SUBJECT: First Partial Report of Test, Military Potential Test of  
Primary Helicopter Trainers, RDT&E Project No.  
USATECOM Project No. 4-7-1000-01

SUBJECT: Evaluation of Basic Helicopter Trainer - Test Helicopter A

SUBJECT: Evaluation of Basic Helicopter Instrument Trainer -  
Test Helicopter A

Figure 2. Crew Compartment View  
A: Instrument Illumination Light Location  
B: Alternate Air Control  
C: Heater Control  
D: Rotor Engagement Clutch Handle

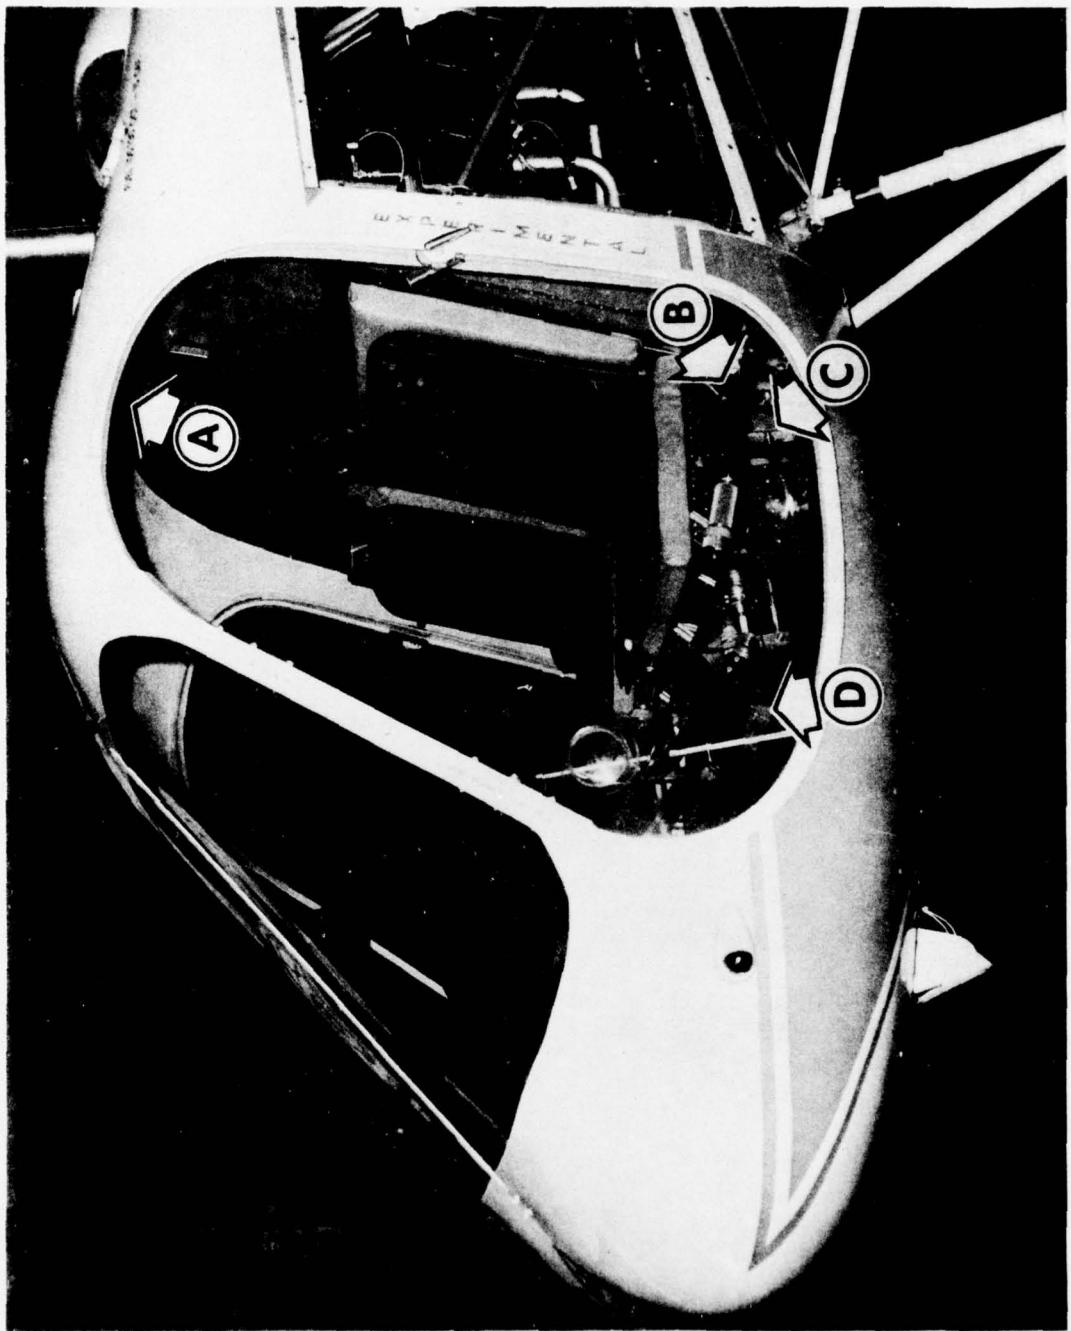
c. Induction system air control located to left of mixture control (accessible to both pilots). Control was located to left of the left pilot's seat and could not be reached by both pilots.

- a. The cyclic and collective control forces required were greater than optimum.
- b. The pedal adjustment range was insufficient to provide optimum comfort for tall pilots.
- c. The doors were difficult to latch from inside.
- d. The door restraint devices lacked adequate strength to prevent damage to the door in high winds.
- e. Only one heat outlet, located on the crew compartment floor, was provided for heating, defrosting, and defogging.
- f. The instrument lighting system was inadequate--a single map light located on the aft bulkhead was the only source of illumination for the instruments.
